Bennett Marine Inc.
Technical Service Bulletin 0145-15
April 17, 2015

EIC Relay Modules, 12V only. Part # EIC101DAD

Identification

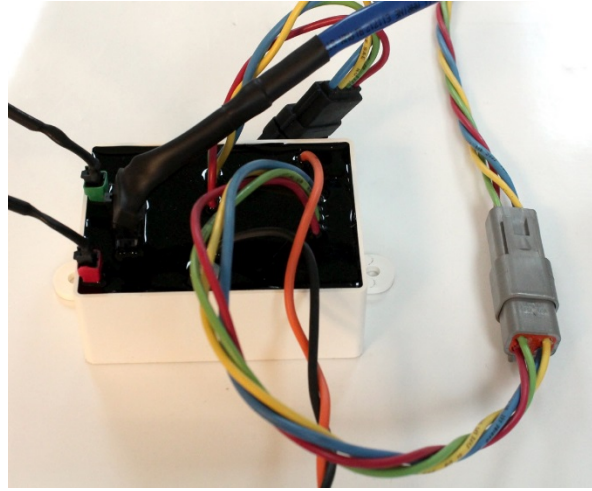
The EIC Relay Modules (EIC101DAD), manufactured and delivered between 11/17/14 and 2/15/15, were constructed with an internal board mounted fuse that is not appropriately rated. This fuse provides circuit protection for the pump valves. Under certain conditions the valves in the pump can draw more current than the fuse is capable of conducting and, by design, the fuse will blow. There are no external signs of this failure and the fuse is not user serviceable. In the event of a failure, the EIC Relay Module (EIC101DAD) must be replaced.

The products covered by this service bulletin can be identified as follows:

EIC101DAD. The product label is located on the bottom of the unit and must be uninstalled to view.

White plastic box 3- $\frac{3}{4}$ " Long, 2- $\frac{3}{4}$ " Wide, 1- $\frac{1}{2}$ " Tall
Black Potting on top of box.
